**COUNTY OF ORANGE**  
**OC PUBLIC WORKS DEPARTMENT**

**Subject: Total Maximum Daily Loads for Indicator Bacteria, Baby Beach in Dana Point Harbor and Shelter Island Shoreline Park in San Diego Bay – Draft Technical Report, February 22, 2008**

**Attachment A****Technical Comments on Total Maximum Daily Loads for Indicator Bacteria,  
Baby Beach in Dana Point Harbor and Shelter Island Shoreline Park in San Diego Bay  
Draft Technical Report, February 22, 2008**

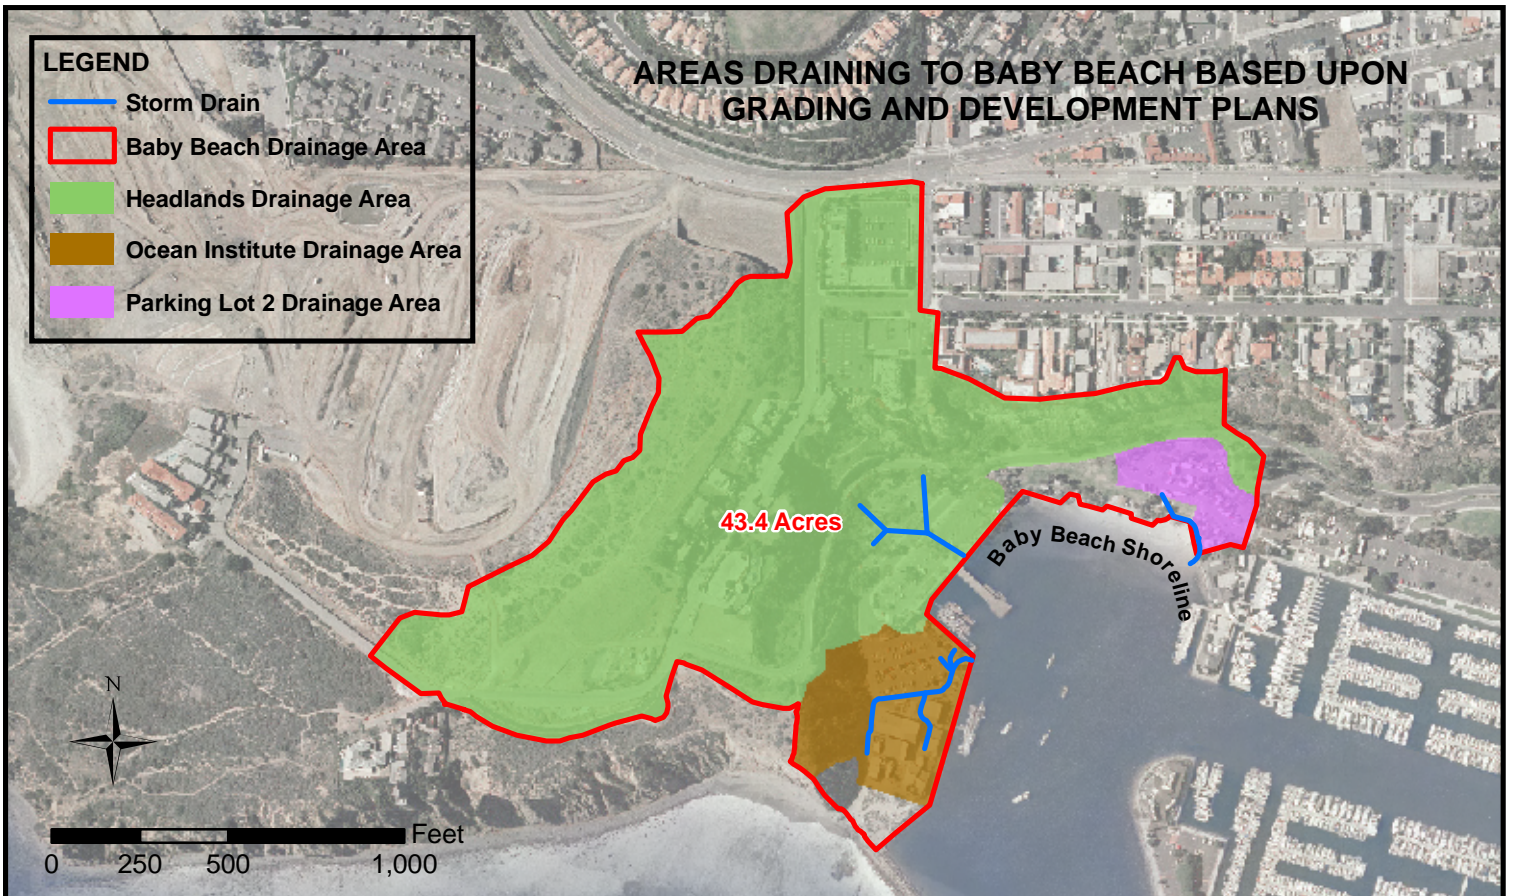
26. Appendix F, Section F.3.3.2.2, Lateral boundary conditions, Page F-40, Fourth Paragraph: The document states, "Contributions from subwatersheds 2101 and 2102 were included as lateral boundary conditions for DPH." This seems to contradict other information in the document (Table 2-1 and Figure J-3) that describe and depict the Baby Beach watersheds as being 522.6 acres and subwatersheds 2101, 2102, 2103, and 2104. If only subwatersheds 2101 and 2102 were used for modeling loading, this would include approximately 195.7 acres. This is still over four times larger than the 43.4 acres shown on area

grading and development plans as draining directly to Baby Beach (see Comment #5).

# Attachment B Baby Beach Drainage Area Map

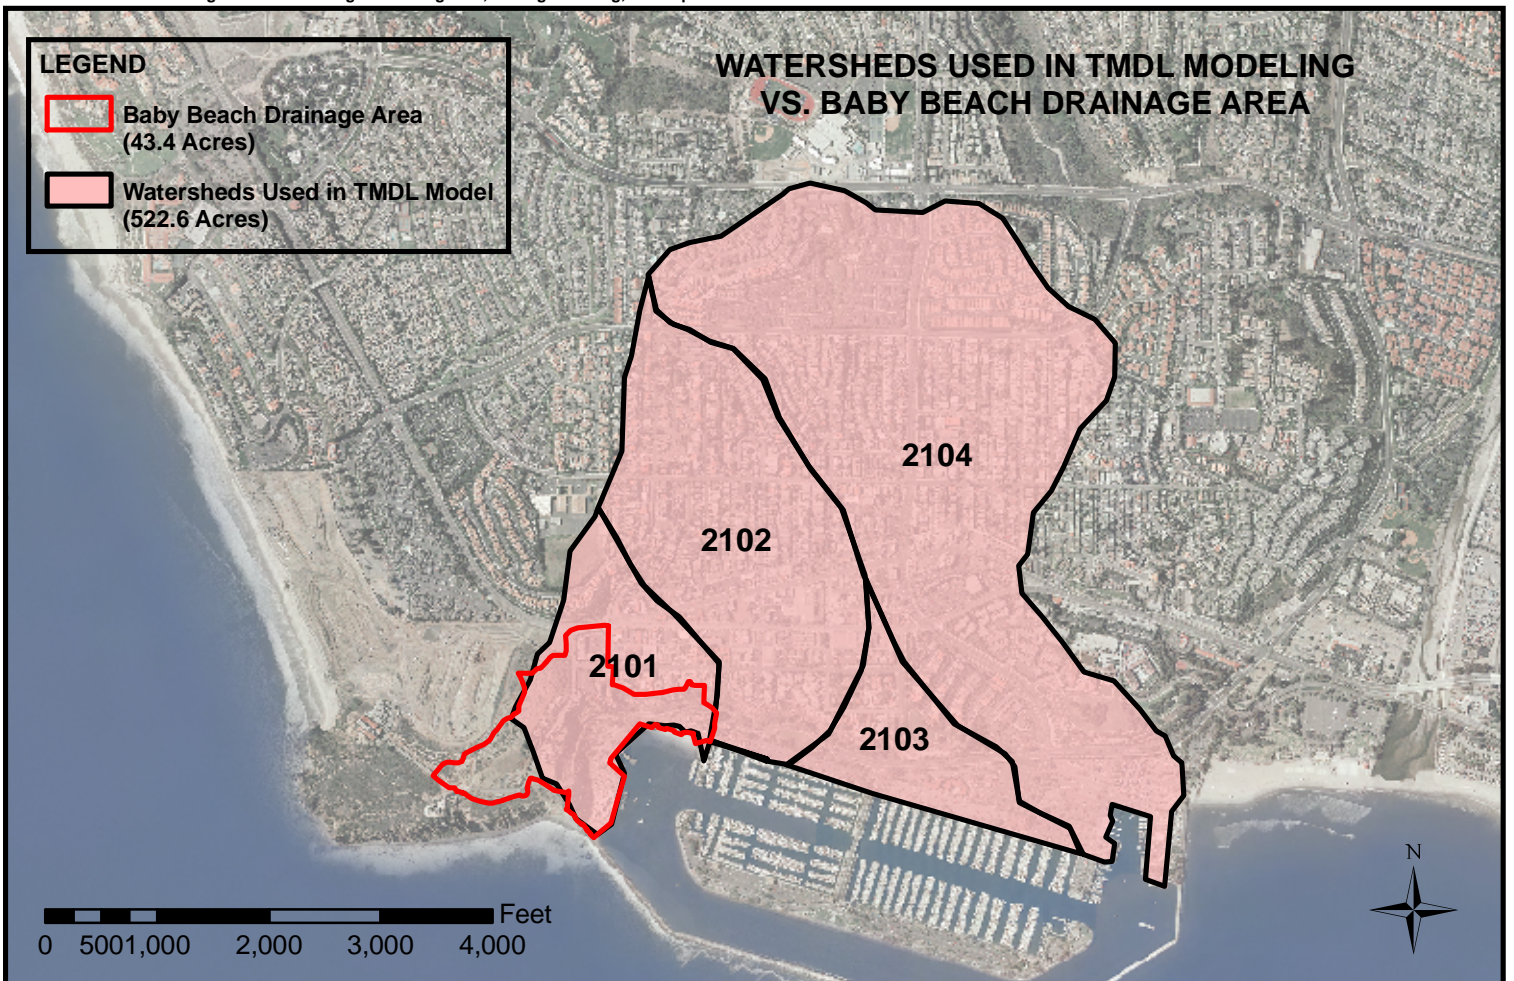
- 4) The inaccuracy of the watershed boundary and resulting land use category calculations used. The Baby Beach TMDL model uses a grossly overestimated watershed area of 522.6 acres to model land use derived bacteria loading from the MS4 system. Grading and development plans indicate only 43.4 acres drain directly to Baby Beach (see also Attachment A, Comment #5 and Attachment B, Baby Beach Drainage Area Map),

18. Section 8.2 Load Allocations, Page 49, Third Paragraph: Better spatial information is available for the coverage of MS4s in the Baby Beach drainage area. Attachment B depicts the Baby Beach drainage area and MS4 subdrainages within it based upon a review of area grading and development plans. As noted in Comment #5, the watershed area used in the model should be revised to reflect the actual drainage area to Baby Beach. A redistribution of WLAs assigned to MS4s should be calculated to account for natural areas not included within coverage of an MS4.
